UNITED STATES
NUCLEAR REGULATORY COMMISSION
WASHINGTON, D. C. 20555

AMENDMENT TO FACILITY OPERATING LICENSE

ATTACHMENT TO LICENSE AMENDMENT NO. 12
CHANGE NO. 27 TO THE TECHNICAL SPECIFICATIONS
FACILITY OPERATING LICENSE NO. DPR-32
DOCKET NO. 50-280

SAFETY EVALUATION BY THE OFFICE OF NUCLEAR REACTOR REGULATION

TS FIGURE 3.1-1

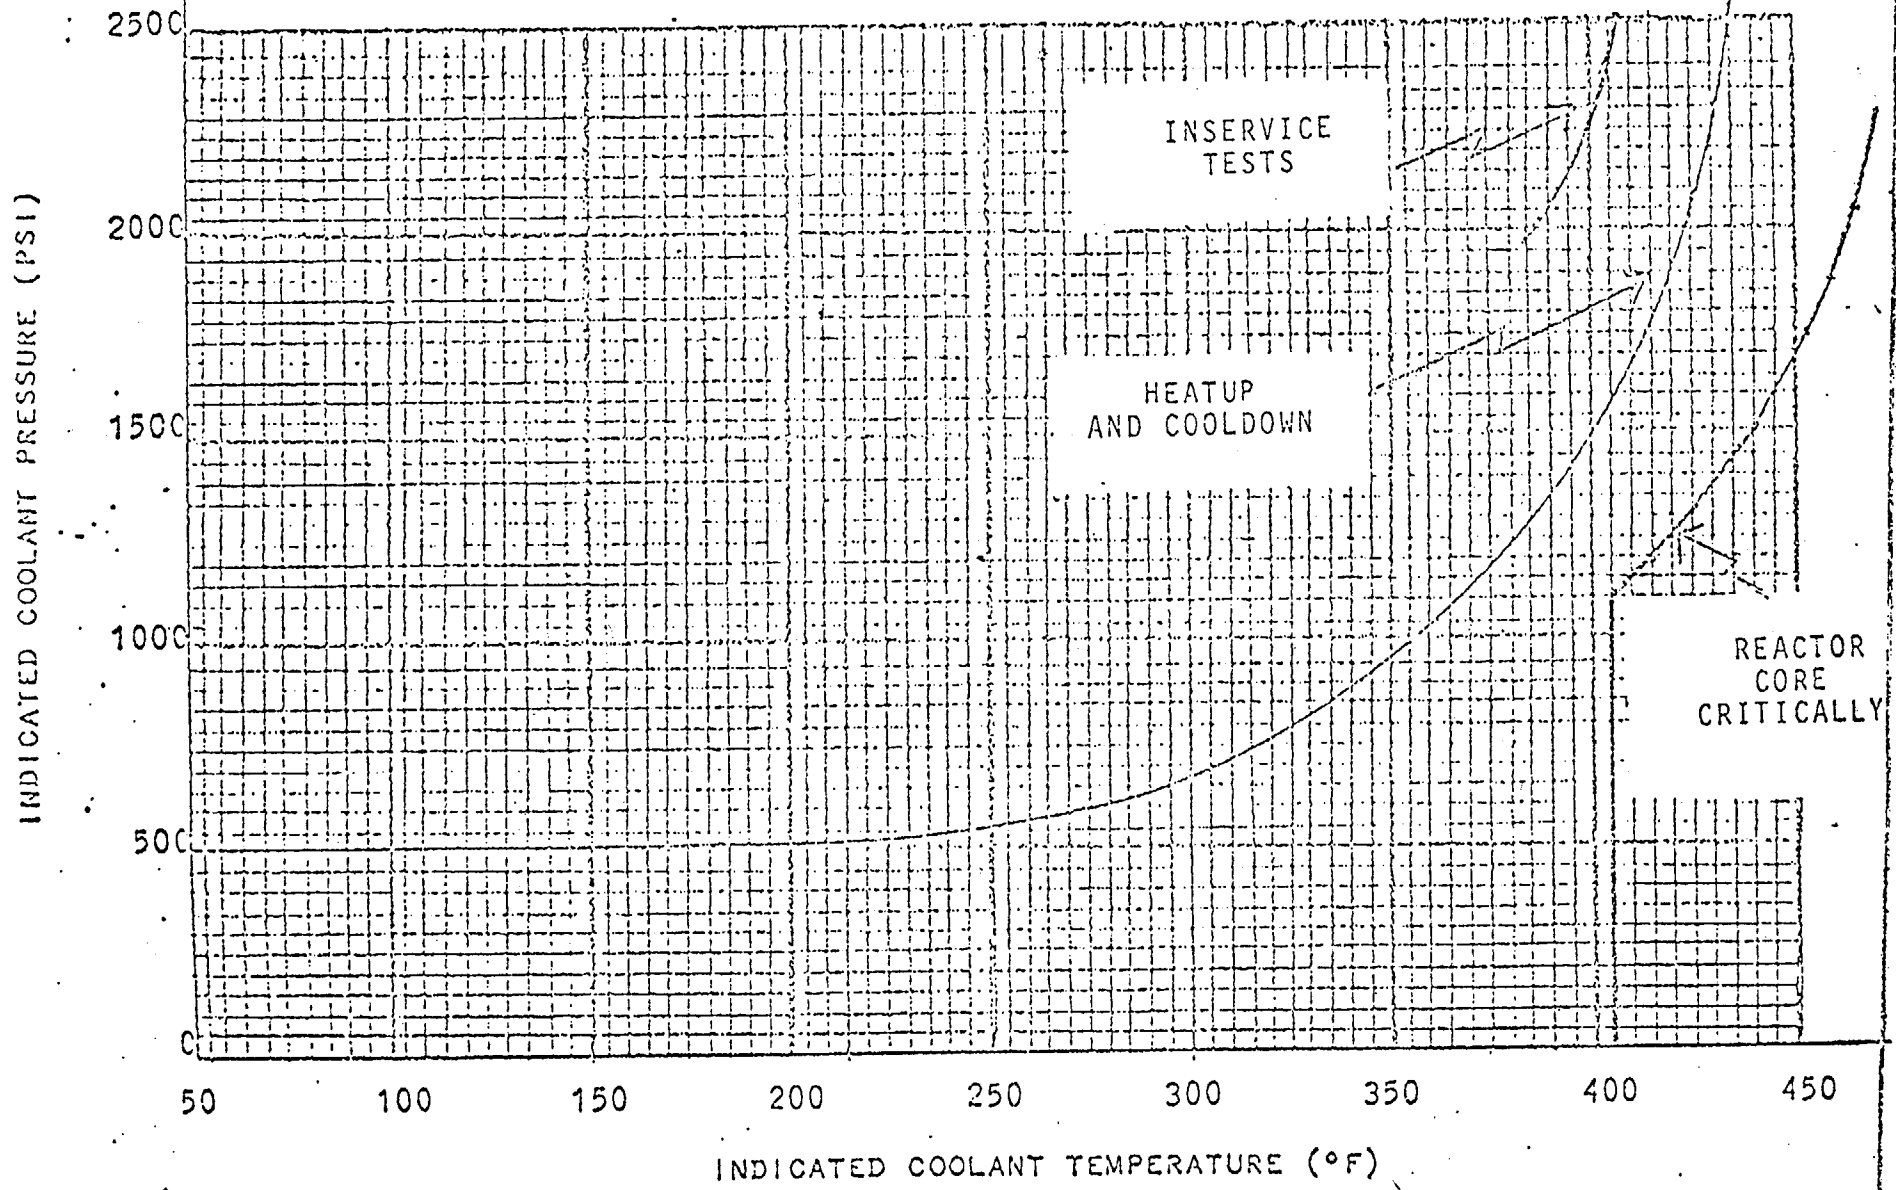
We have evaluated the pressure-temperature limit curve presented in Figure 3.1-1 of the licensee's proposed Technical Specification Change of October 22, 1975 and conclude that it is acceptable for heatup and cooldown pressure-temperature limits. We have augmented this curve to indicate pressure-temperature limits for inservice hydro testing and core criticality. The attached curves provide acceptable limits for these conditions.

"Core Operation:

During operation where the reactor core is in a critical condition (except for low level physics tests), vessel metal and fluid temperature shall be maintained above the reactor core criticality limits specified in Figure 3.1-1."

"The pressure-temperature limits for these tests will be in accordance with Figure 3.1-1."

1. Unit 1 and Unit 2 reactor coolant temperature and pressure and the system heatup and cooldown (with the exception of the pressurizer) shall be limited in accordance with TS Figure 3.1-1.

Figure 3.1-1 may be used for heatup rates of up to 50°F/hr. below an indicated temperature of 440°F and 100°F/hr. above 440°F.

Allowable combinations of pressure and temperature for specific cooldown rates are below and to the right of the limit line as shown in TS Figure 3.1-1. This rate shall not exceed 50°F/hr. for temperatures at or below an indicated temperature of 440°F. For temperatures above an indicated temperature 440°F, the rate shall not exceed 100°F/hr.

During operation where the reactor core is in a critical condition (except for low level physics tests), vessel metal and fluid temperature shall be maintained above the reactor core criticality limits specified in Figure 3.1-1.

Figure 3.1-2. Radiation Induced Increase In Transition Temperature

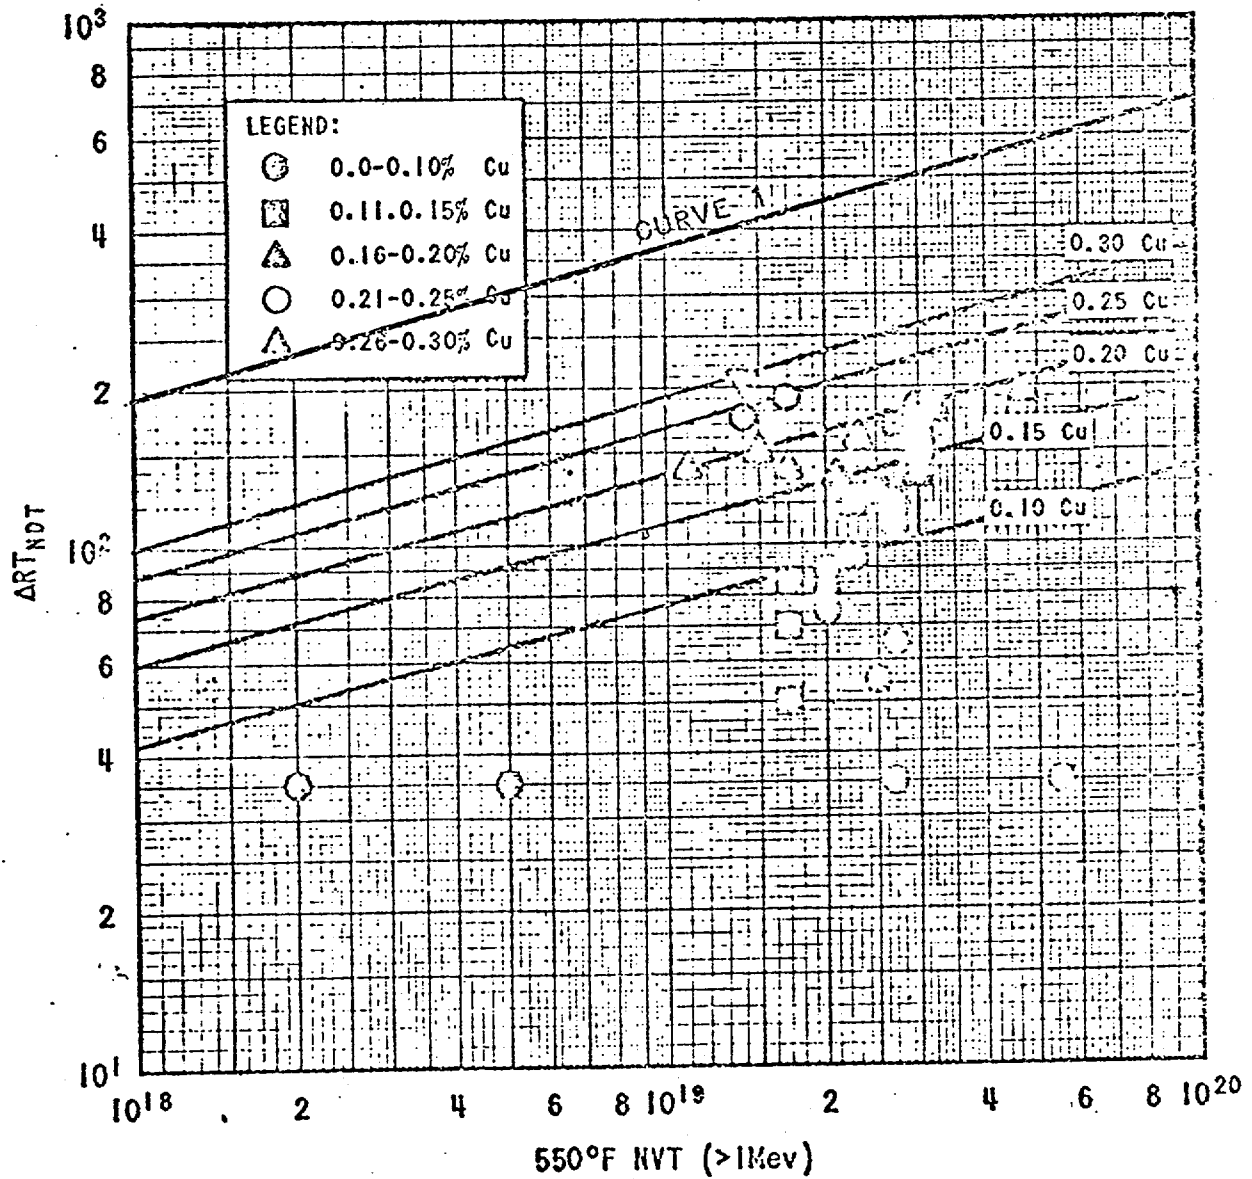
NOTE: CURVE 1 BASED ON ACTUAL IRRADIATION DATA FOR UNIT 1 FROM JUNE 24, 1975 BATTTELLE COLUMBUS LABORATORIES REPORT
